HALEY & ALDRICH, INC. 8101 E Prentice Ave, Suite 6 Greenwood Village, CO. 801 Tel: 720-616-4400 www.haleyaldrich.com

PIONEER MATERIALS SOLBERG PIT GRADING AND EROSION PLAN

**COVER SHEET**

G-100

C-200

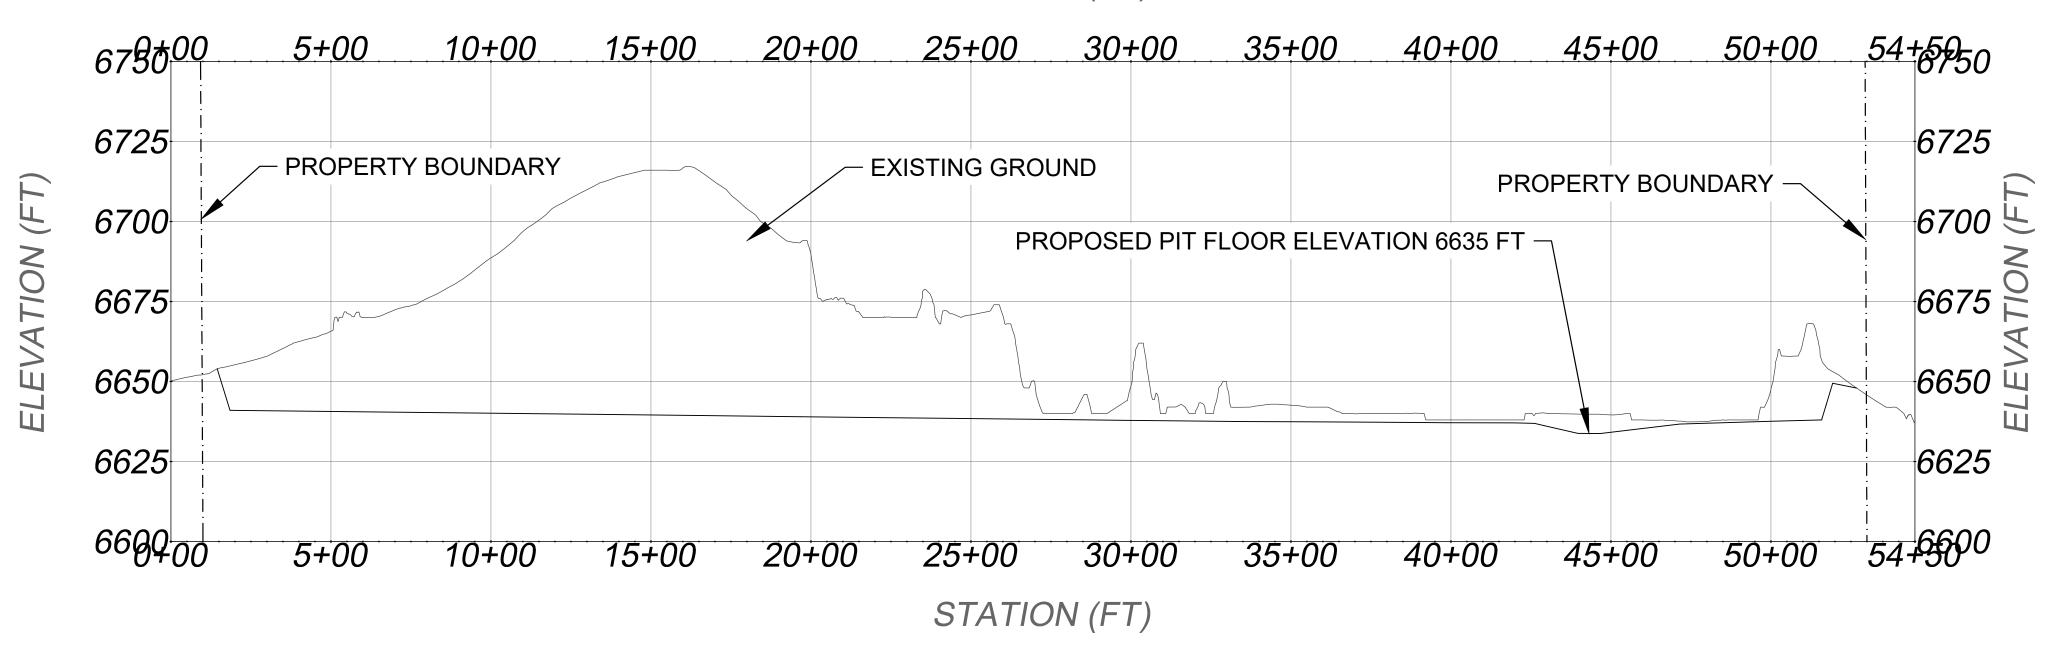
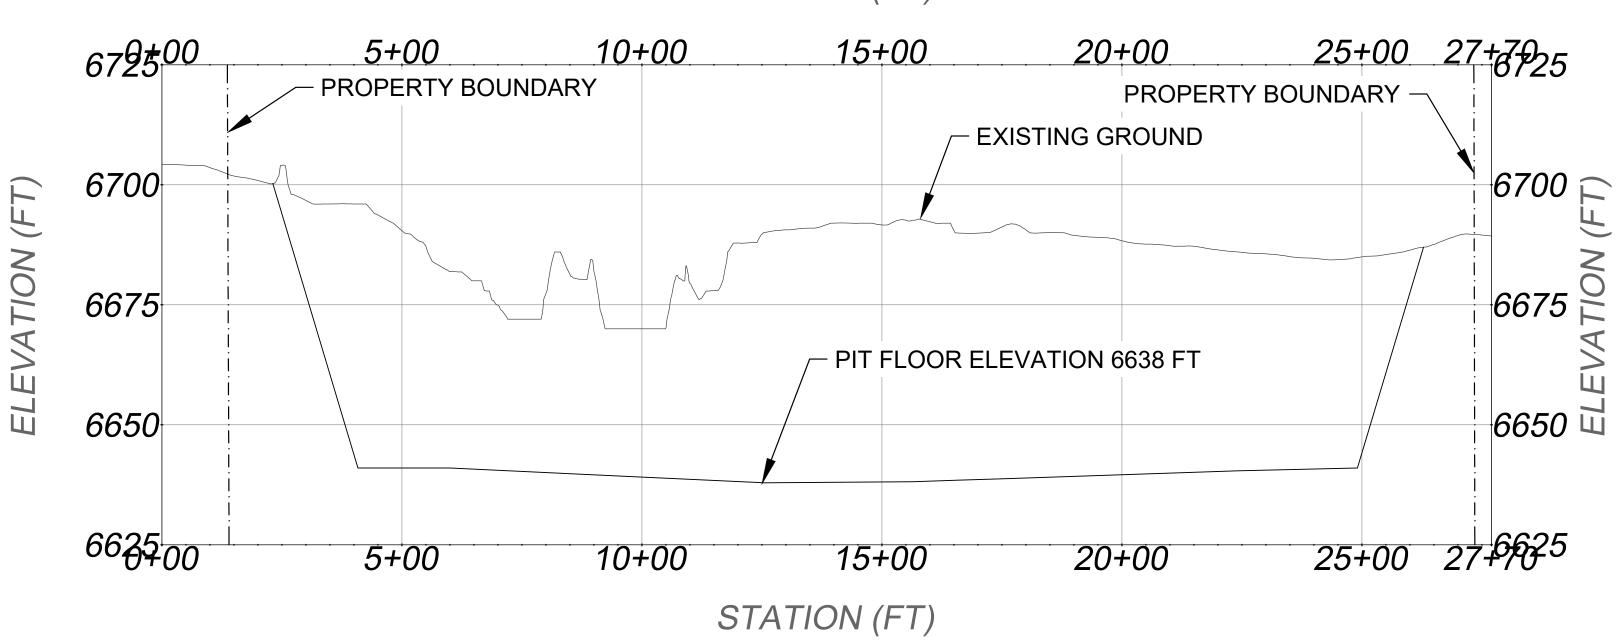
remove from GEC plan set. submit GEC checklist separately. The updated GEC Checklist can be found here: https://publicworks.elpasoco.com/stormwater/
